Re: Comments on the Draft Master Order

Re: Keller-Bliesner Engineering and Balleau Groundwater Comments on the R9 Ranch Modeling Report

Figure 1
Historical Measured Water Levels and Annual Precipitation the R9 Ranch

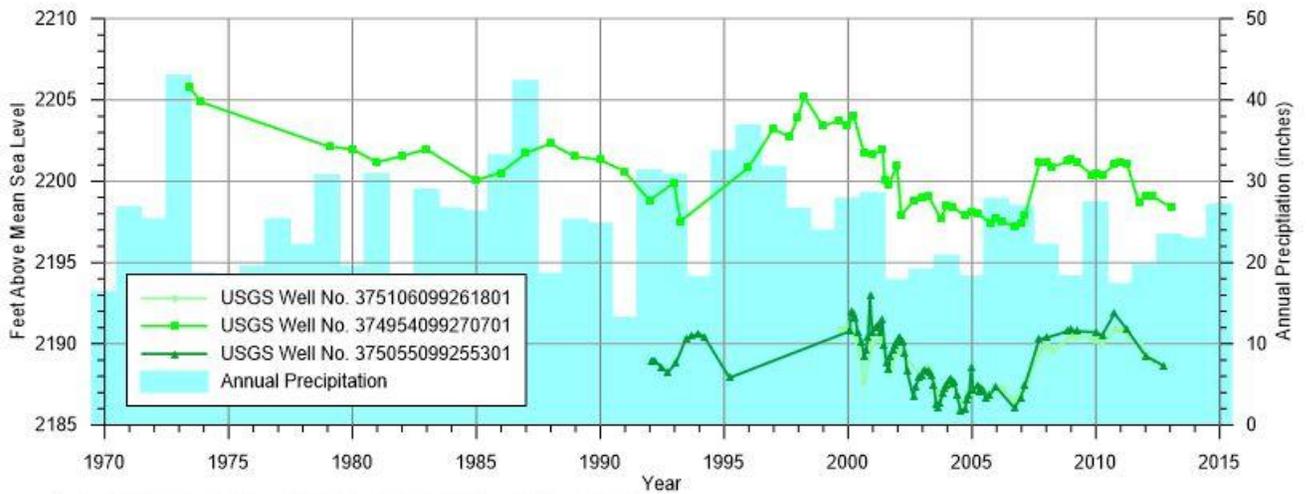
To illustrate the importance of starting scenario simulations with existing conditions, look at the KGS WIZARD reported water levels for the USGS monitored irrigation wells near the R9 Ranch with data for January 1991 and January 2016. These data indicate an actual average water level nearly 8 feet lower in 2016 than in 1991 (see Table 1 below).

- Referring to a decline in water levels between two specific points in time does not indicate an actual declining trend in water levels. As can be seen in Figure 1, illustrating the historical trend (1973-2013) of water levels at the three USGS monitoring wells located on the Ranch (Figure 2), water levels fluctuate four feet from average but are relatively stable throughout the period.

Figure 3

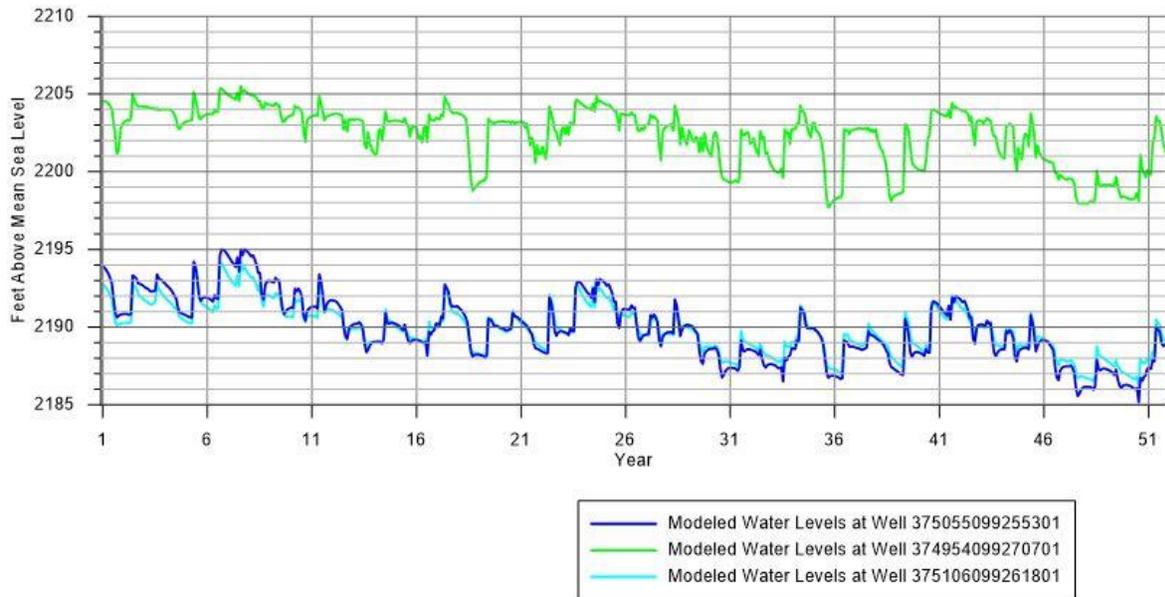
1. *The BMcD report water level contour figures (6, 9, 10, and 13) were created by subtracting the model generated ending water levels for the associated municipal well pumping scenarios from the model generated ending water levels for the irrigation pumping baseline scenarios. Not shown or reported are the change in model generated water levels from the beginning to the end of each scenario or the model generated ending water levels for the municipal scenarios. The latter can be derived by combining BMcD Figures 6, 9, 10, and 13 with the associated baseline Figures 5, 8 and 11, however not providing change in water levels and ending water levels masks the magnitude of the decline in water levels under all scenarios. For example, if one compares elevations from Figure 5 (Scenario 1: 1991-2007 Historical Irrigation Pumping) to those at the end of the 51-yr Historical Irrigation simulation (Scenario 3) in Figure 8, on average there is about a 5 to 10-ft drop in water levels. Combining that drop with Figure 9 indicates that at the end of the 51-year municipal pumping of 4,800 acre-feet/year simulation (Scenario 4) the model generated drop in water level is as great as 10 feet from the 2007 levels. Additional figures showing the water level contours at the end of the municipal pumping scenarios, like Figure 8 for the irrigation baseline, and change in water levels from the beginning to end of simulation, would be helpful.*

- The BMcD runs of the 51-year baseline irrigation model produce water levels that are slightly lower (approximately 4 feet), but not 10-15 feet lower at the end of the 51-year model as referenced by K-B. Figure 3 is a graph showing the model generated water levels at the three USGS monitoring well locations located on the R9 Ranch. Water level elevations fluctuate on average four to five feet correlating to changes in

recharge, pumping, and season. It should be noted that the water levels plotted on Figure 3 are from the revised model runs with the SFR package operating correctly.

Figure 4 -
 Comparison of Historic and Model Generated Water Levels

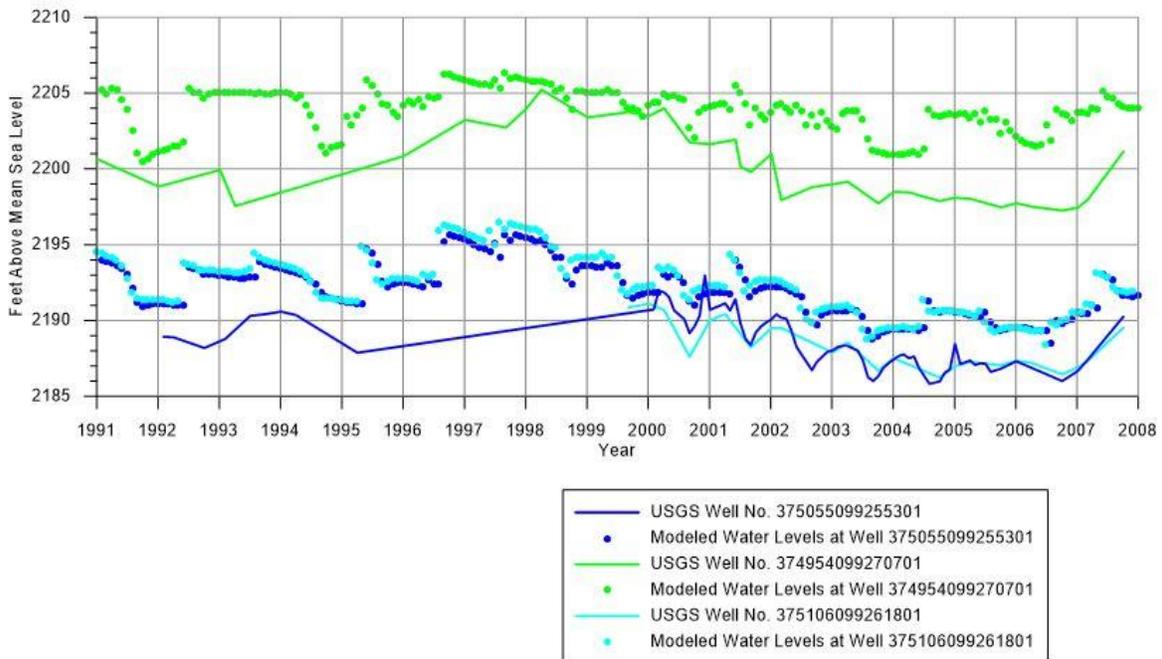
- 5. From BMcD report page S, second paragraph: "As shown in Figure 3, water levels calculated by the model from 1991 through 2007 correlate well with the observed water levels from USGS monitoring wells located on the R9 Ranch." We would like to see plots of model generated water levels for the same model cells as the USGS monitored irrigation wells located on and near the R9 Ranch. We note from Table 1 above that the model appears to have a significant bias towards generating water levels higher than the USGS monitored irrigation wells near the ranch. January 2008 reported water levels for some monitoring wells near the ranch are 9 to 18 feet lower than the model generated waters for the baseline irrigation Scenario 1 (see Table 1 above and BMcD report Figure 5).*

K-B is clarifying that on Figure 3 of the BMcD report, the simulated water levels are not shown in the same model cells where the USGS monitor wells are located. We interpret

- The wells used in the BMcD report represent the locations of observation wells installed in 2014 and intended for water level monitoring into the future.
- Figure 4 illustrates the water levels measured at the three USGS monitoring wells on the R9 Ranch and compares them to the model generated water levels at those same locations. It should be noted that the model generated water levels plotted here are from the revised runs of the model, where the SFR package is running correctly.
